La Marzocco Technical Bulletin #101

New MP O-Ring and MP Group Update Kit

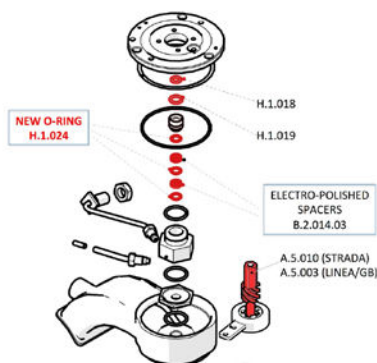
New part number H.1.024 cancels and replaces previous part number H.1.011.01. All MP configuration machines produced after March 2015 have group caps marked with a 'K' to indicate that they have been fitted with the new O-rings (see picture below). This update affects units produced after the following serial numbers:

To update MP machines with serial numbers prior to those indicated, retrofit kit 926 (927 for Strada MP) must be installed on each group. The retrofit kit includes a new paddle shaft and new polished spacers to ensure maximum service life of the new O-rings. One retrofit kit is required to update each group and includes the following parts:
